Suburban Hospital: Site Plan Amendment 82012018A

Staff Report Date: 10/7/2016

COMPOSITE SITE PLAN AMENDMENT

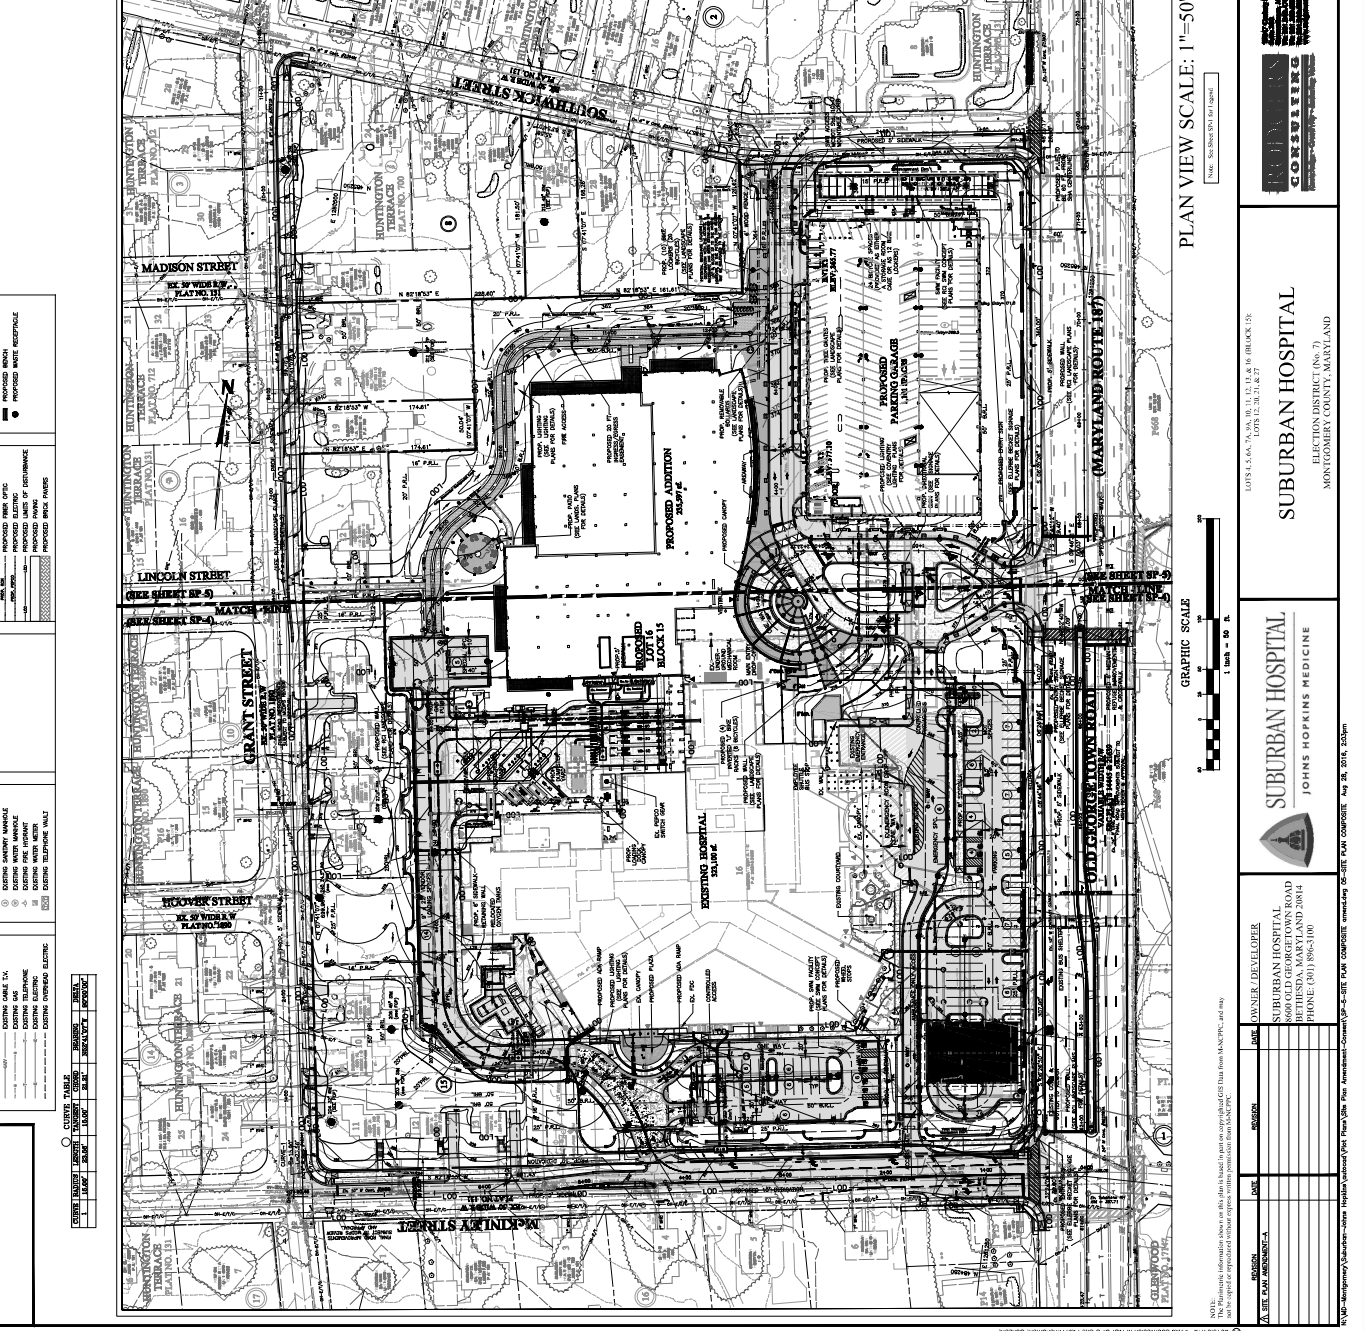
1. Prior to approval of the Certified Site Plan, revise all applicable sheets so that garage entrance and exit striping and lane markings are not overlain with parking space markings from other garage levels.
